SERVICE INSTRUCTION

SI-32-07
Revision 0

TITLE: Rebound Puck Replacement

Figure 1 Access Cutouts Location

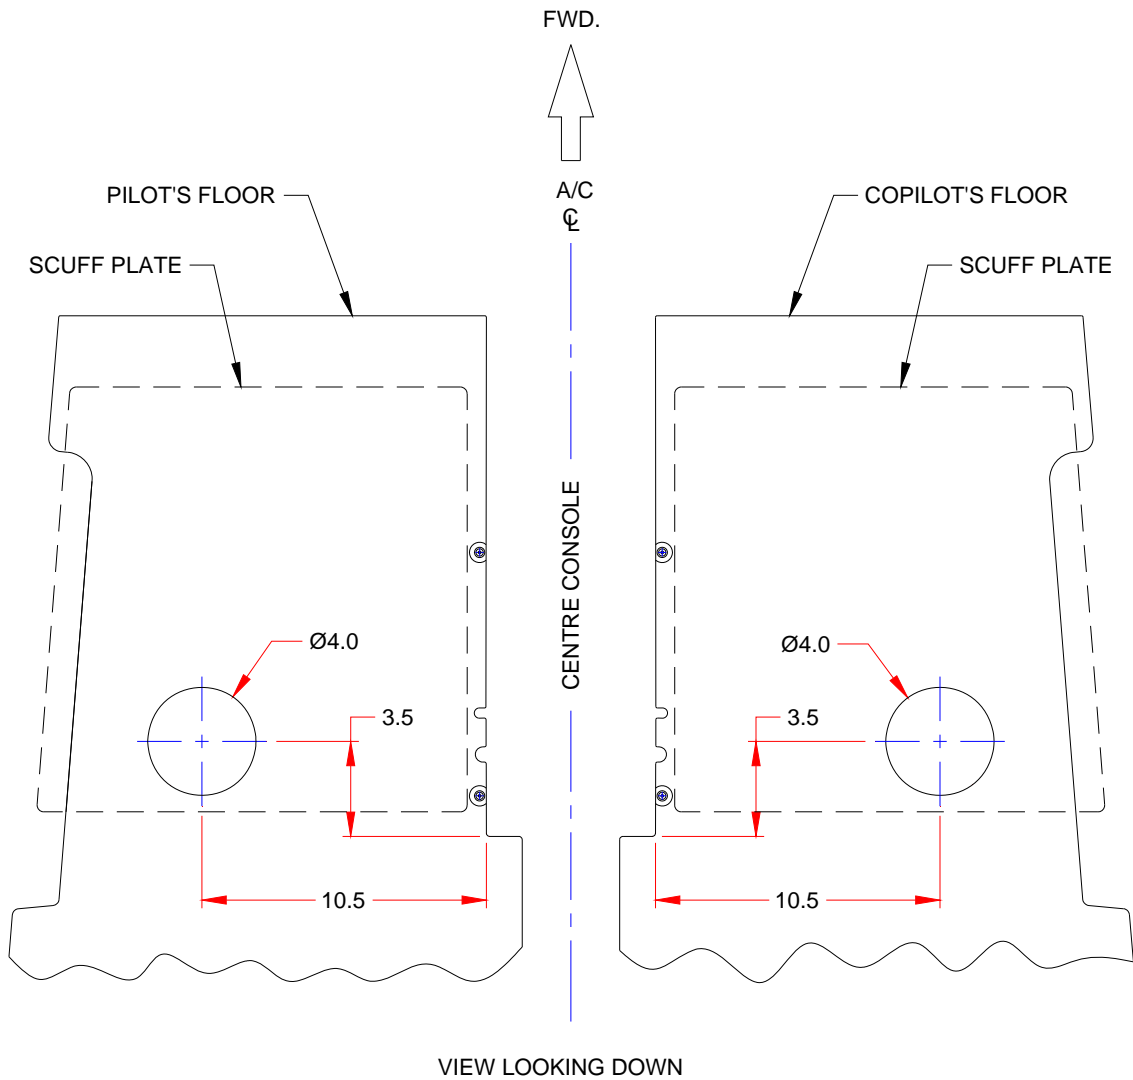
6. Cut access holes in the floors. It is recommended to use a vacuum to minimize dust.
7. Clean reworked area by vacuuming and seal exposed edges of the access holes with good quality wood sealer.
8. If the aircraft is not equipped with scuff plates, use FAC-SI-32-07B R00 kit.
 - a. Place scuff plates on the floor such as they cover the access holes.
 - b. Using the scuff plates as templates, drill pilot holes in floors (Drill #21). Use a drill stop so as not to damage parts under the floor.
 - c. Open the holes up to Drill #8.
 - d. Install the T-Nuts wet with 5 min. epoxy or equivalent.

Figure 2 Shock Absorber Assembly

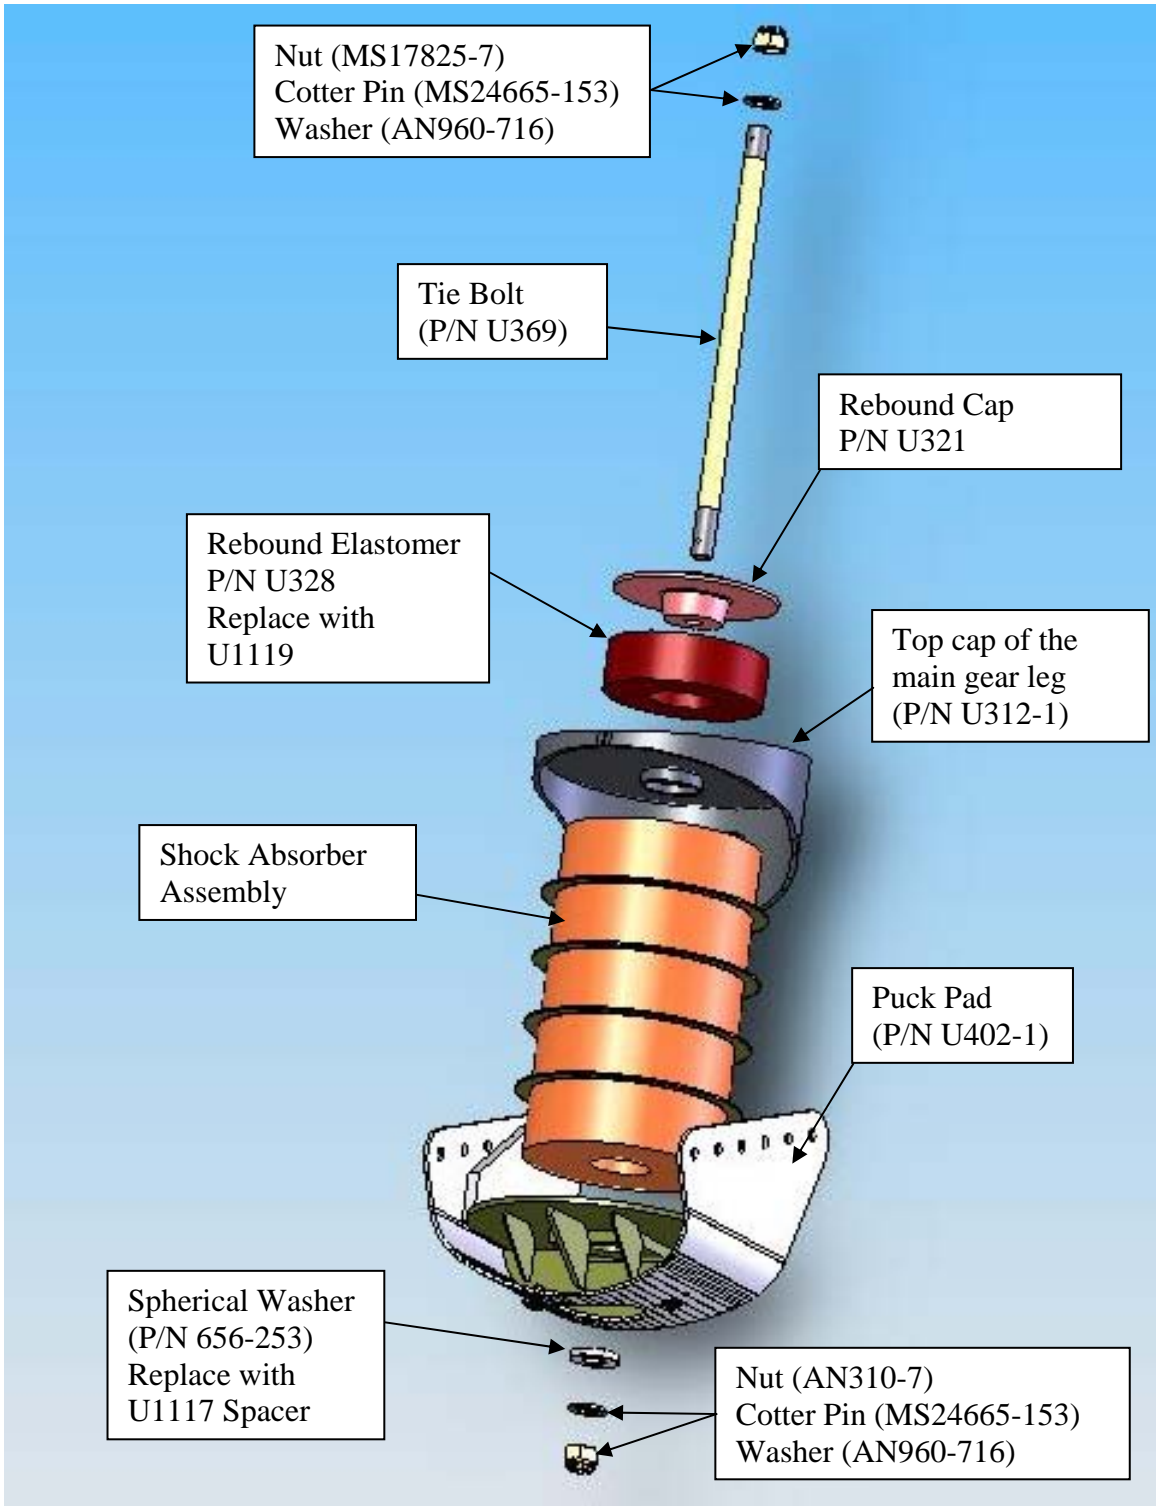
3. With the full weight of the aircraft on the landing gear there should be free play in the spherical washer at the bottom end of the tie bolts as shown in Figure 2. If this is not the case more weight must be added to the aircraft until the washers are free.

Figure 3 Shock Absorber Spacer Installation

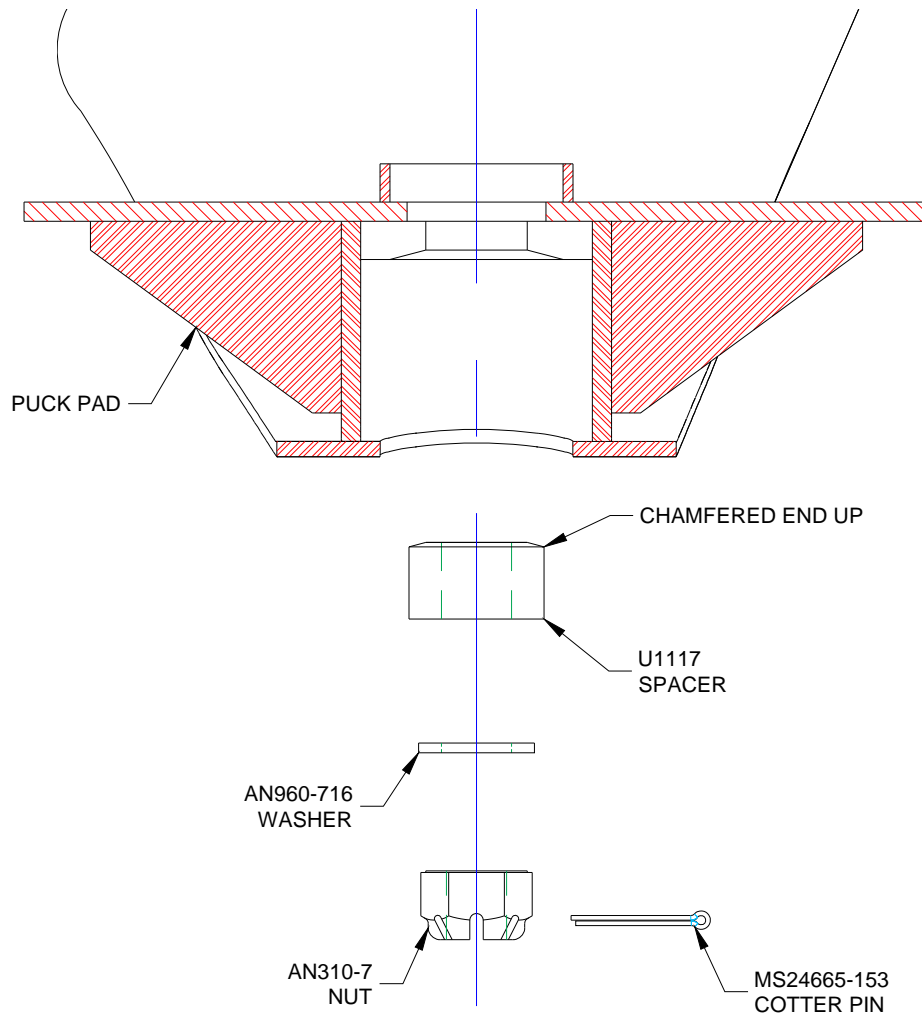
10. Install the nut and secure with a cotter pin. Note the nut should thread on easily. However, due to the replacement of the spherical washer with the U1117 spacer, there may be more weight required on the aircraft in order to secure the nut with the cotter pin. If so, add weight to the aircraft as required.
